ADDENDUM NO. 1

HC Wheatley Institute 3<sup>rd</sup> Floor

## **Project: Wheatley Institute – 3<sup>rd</sup> Floor Renovation**

### **ADDENDUM NO. 1**

**M9243**  
**A5.1**

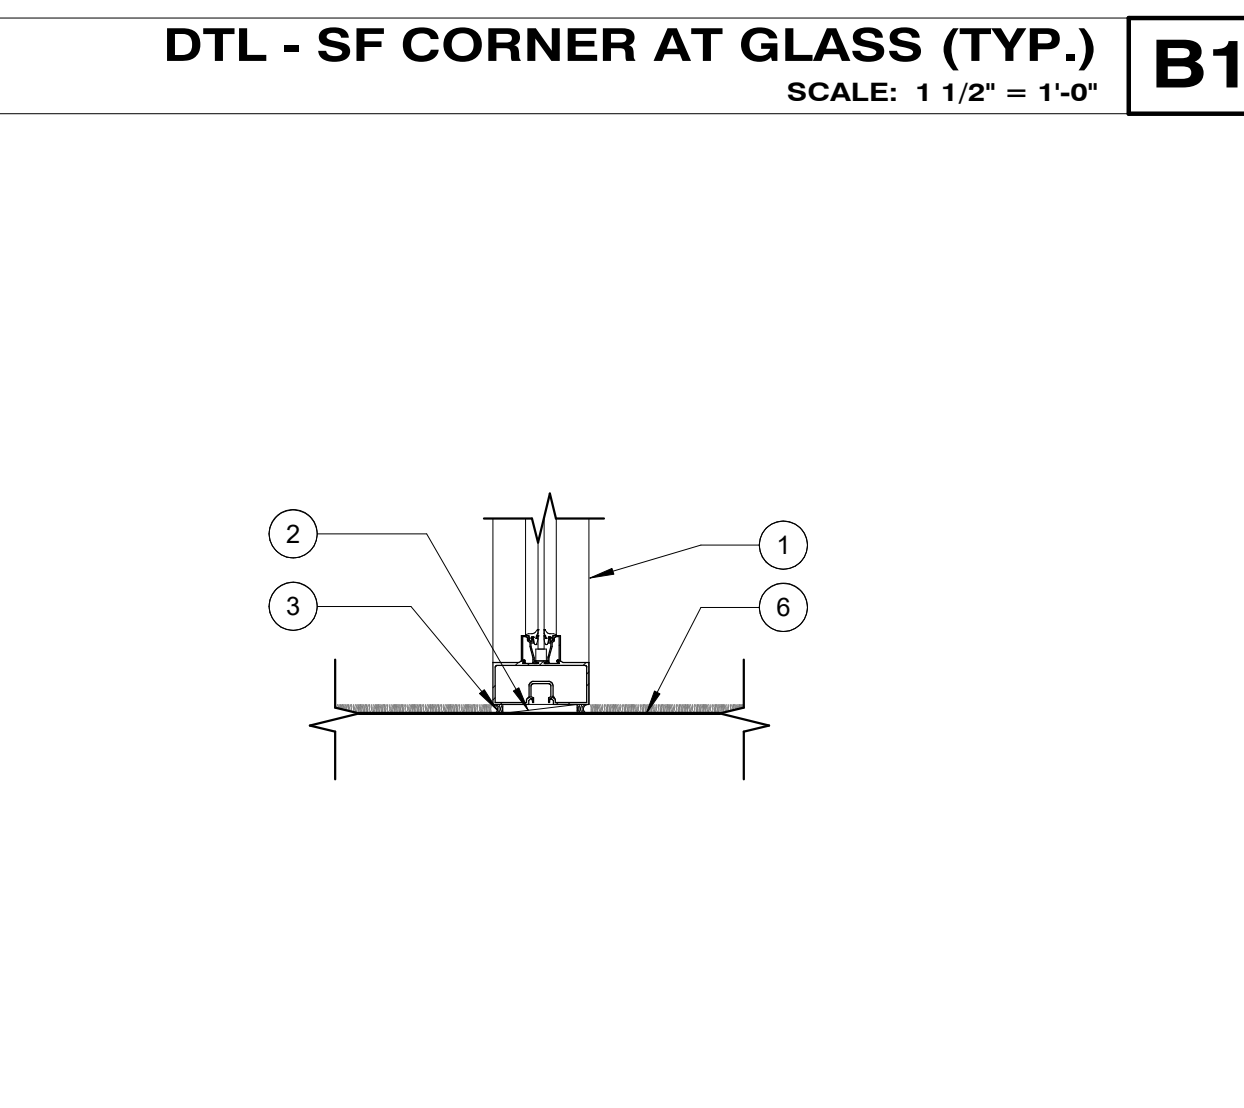
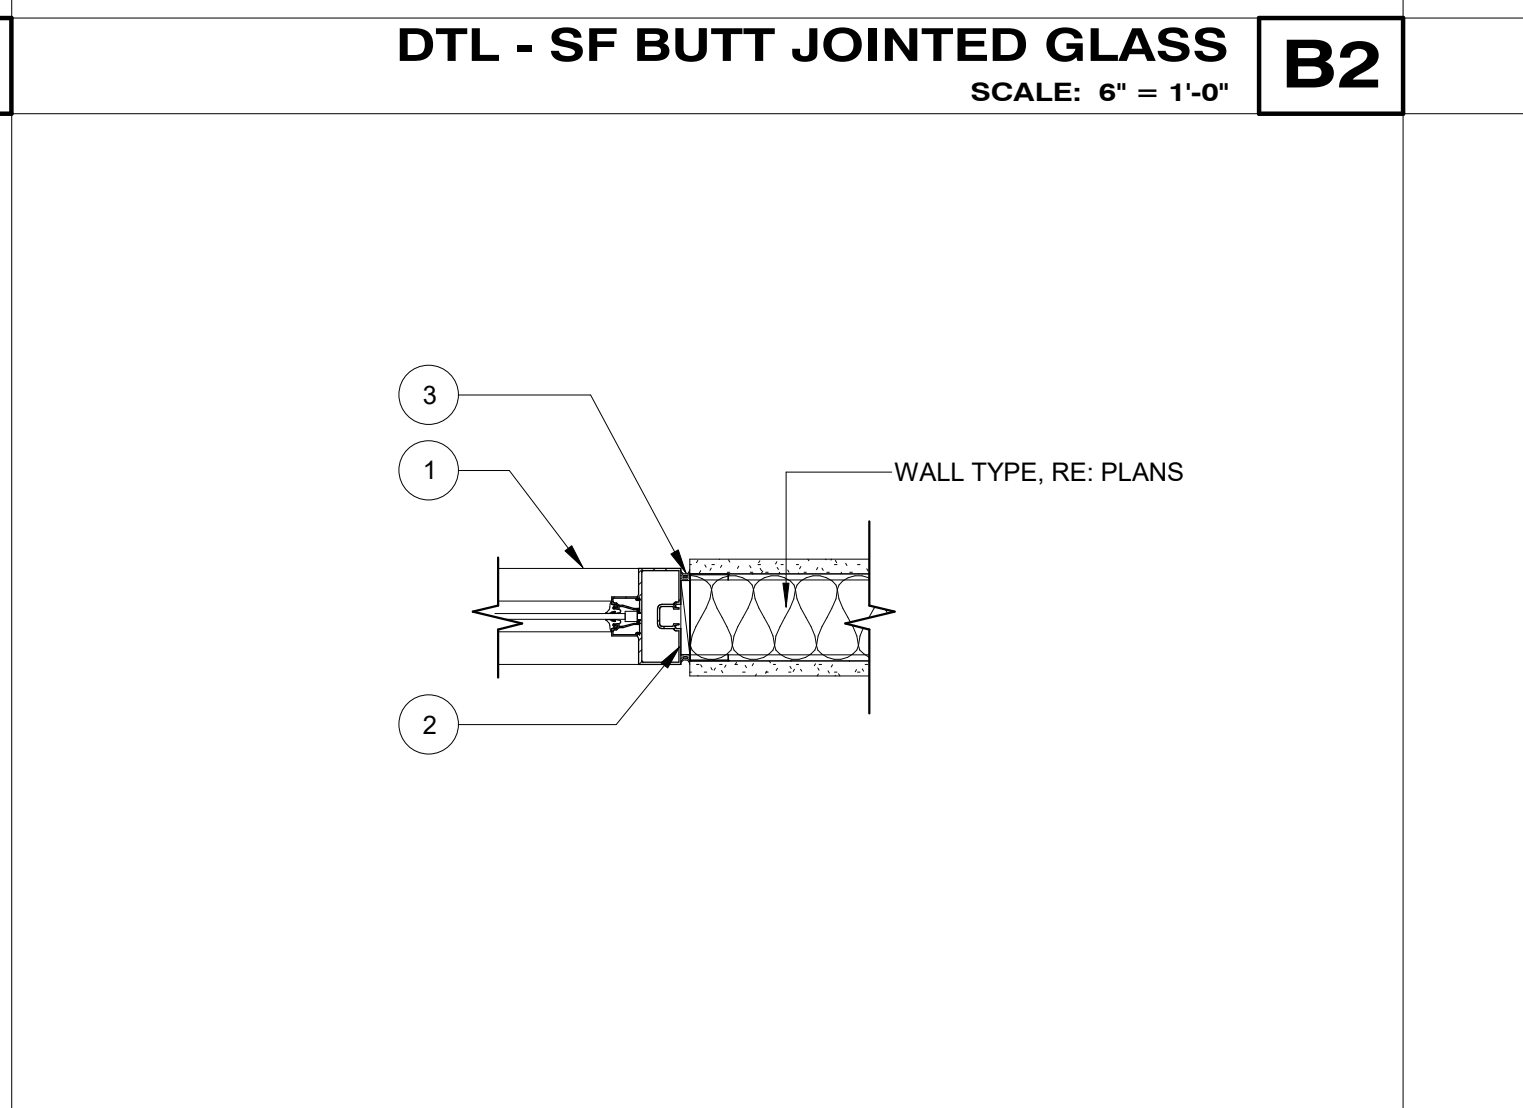
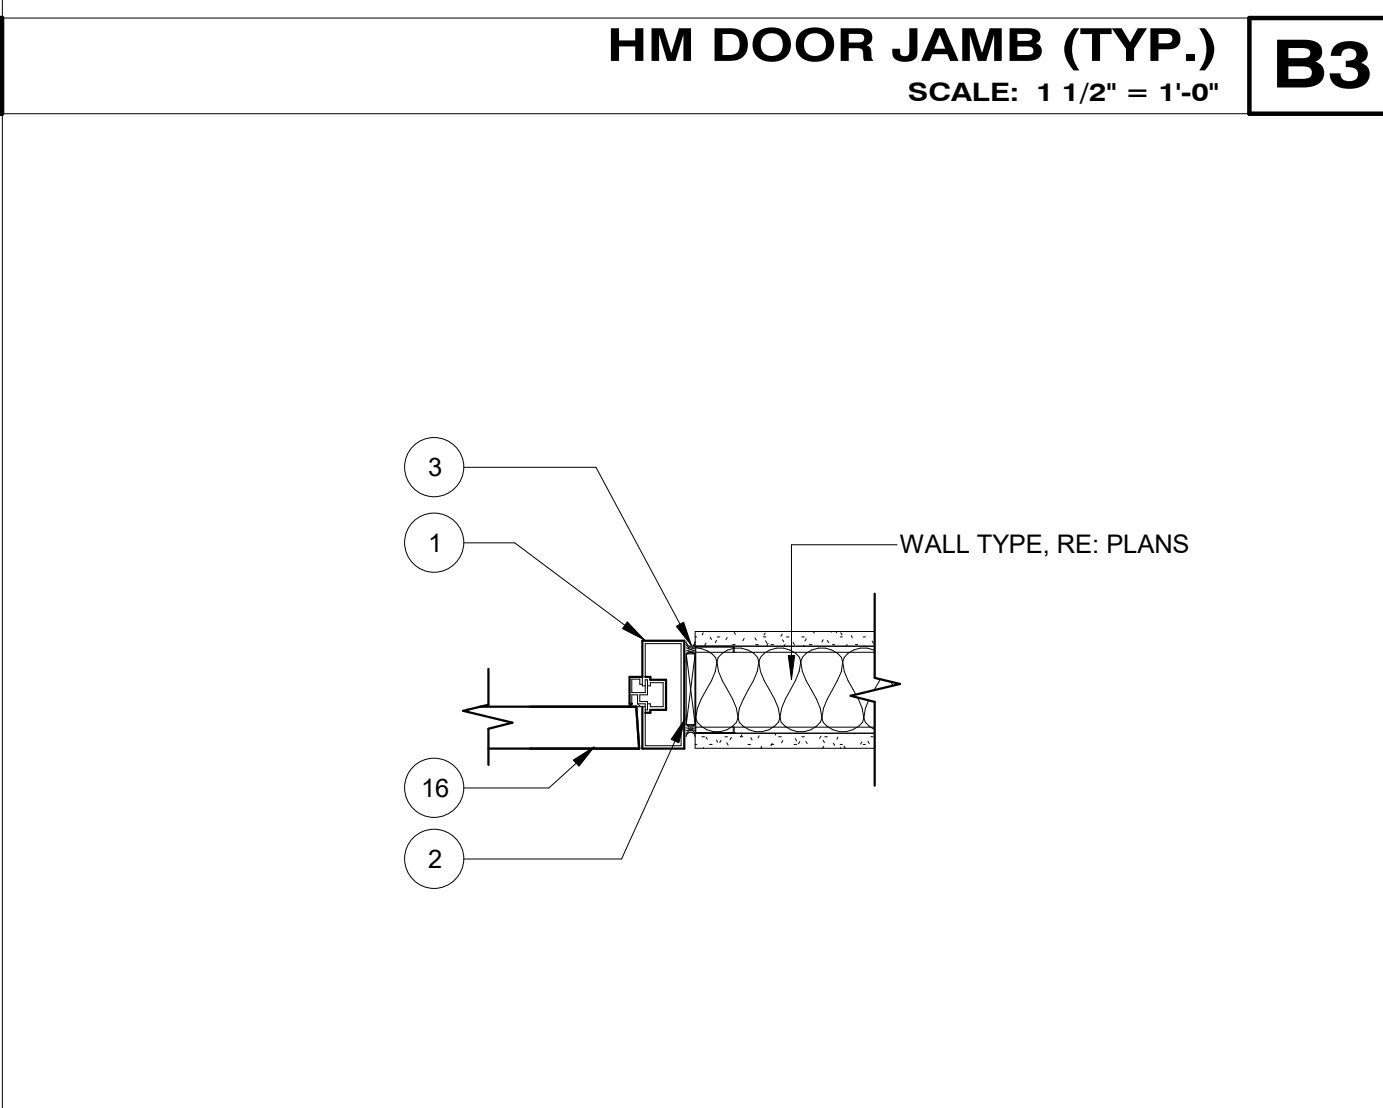
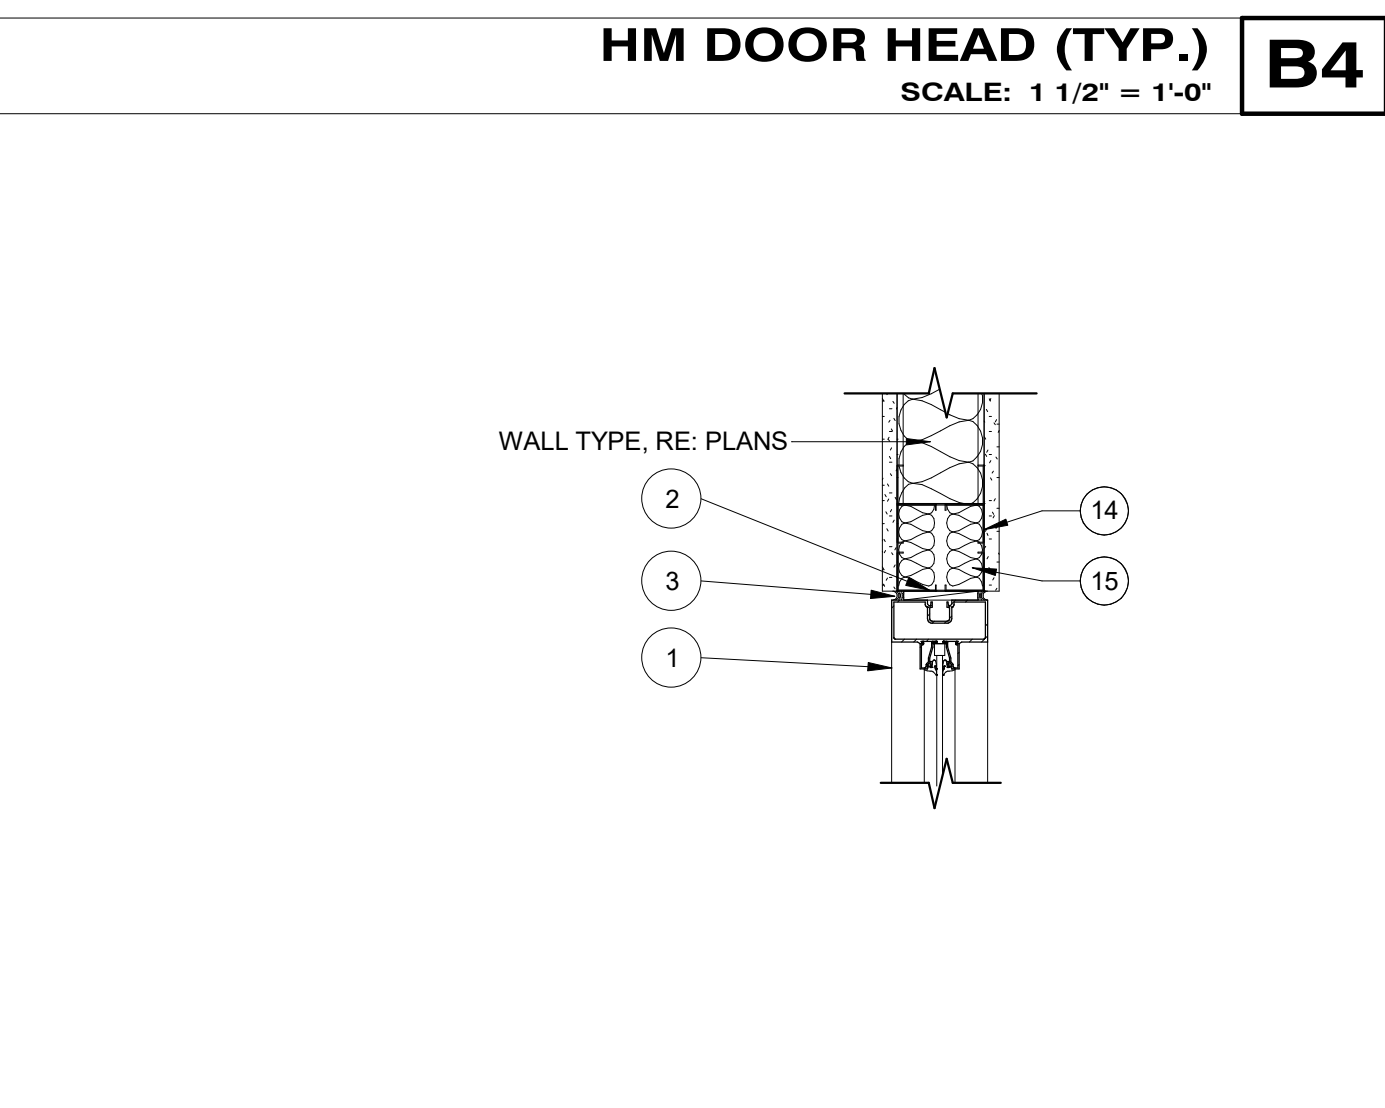
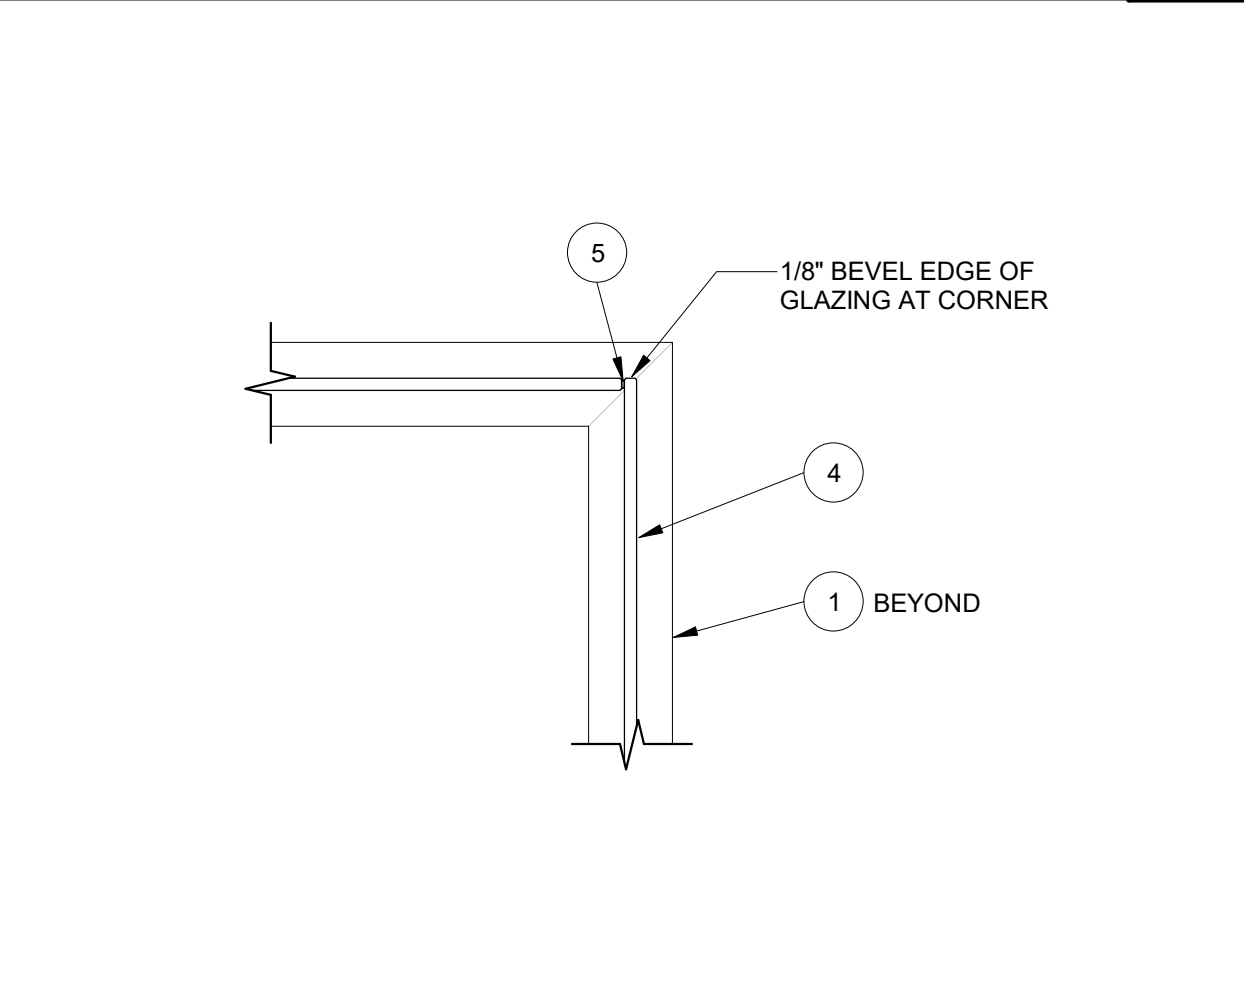
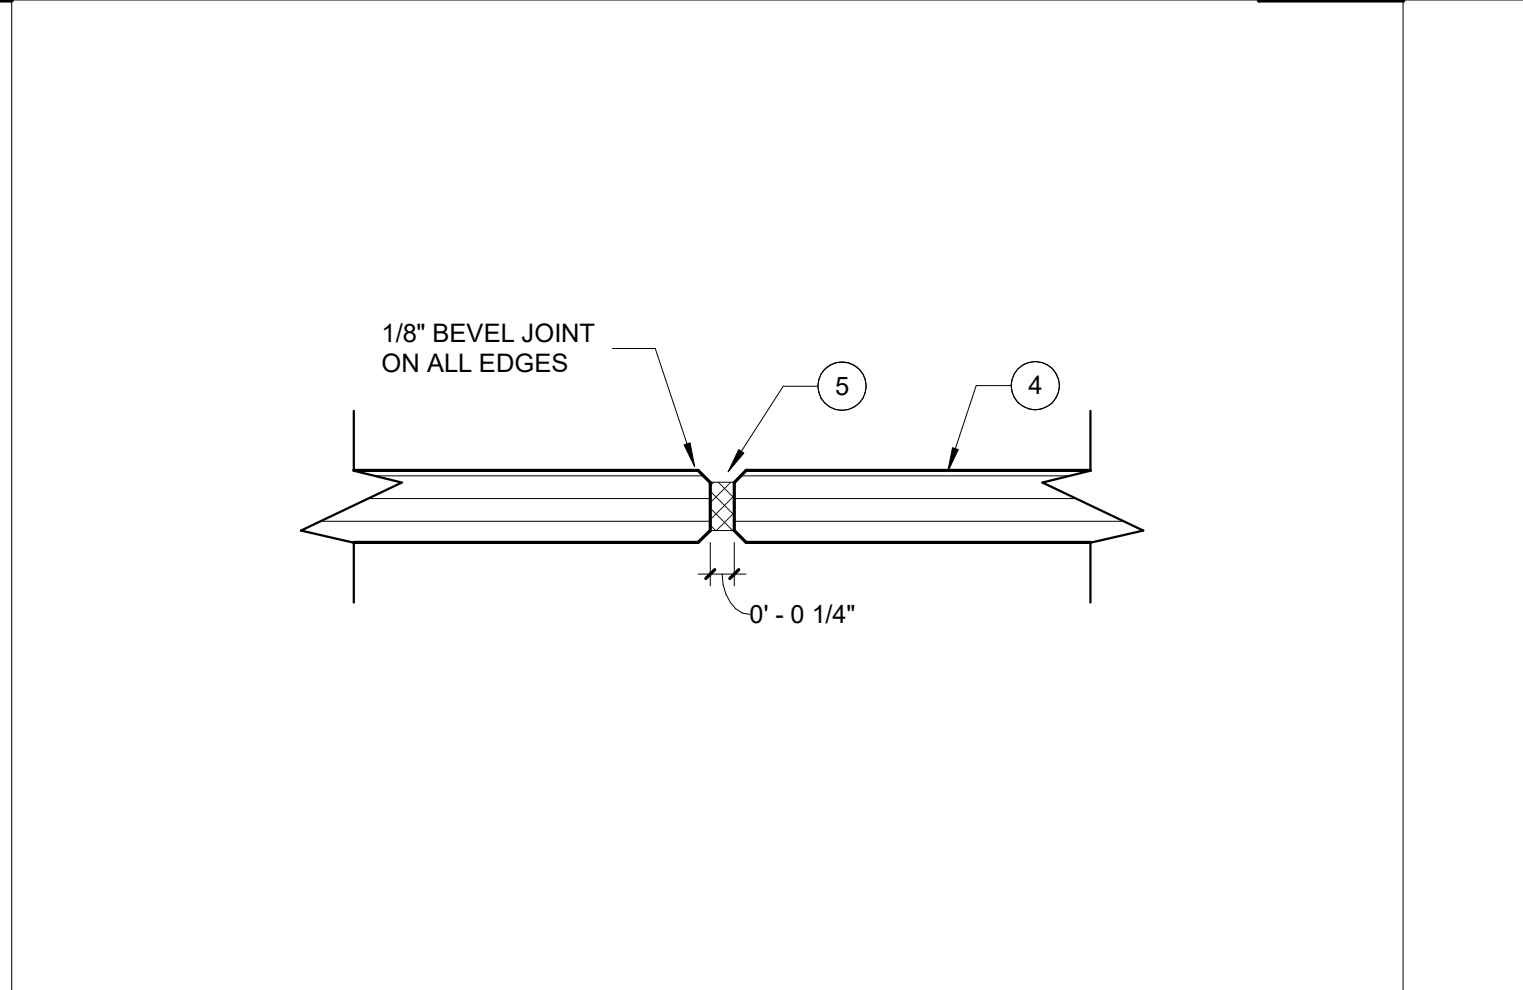
- REVISE: Detail 1 & 3 to show locations of Fire Extinguisher Cabinets and added sheet keynote references.
6. **Sheet A5.1:**
  - ADD: Detail D2 to sheet to show top of feature wall condition along with associated reference sheet keynote 17 to clarify scope on who responsibility to install wood cap.

- 16 FLUSH WOOD DOOR, RE: SCHEDULE.
- 17 (N.I.C.) 1X HARD WOOD CAP INSTALLED AND FASTENED TO TOP OF WALL BY BYU.
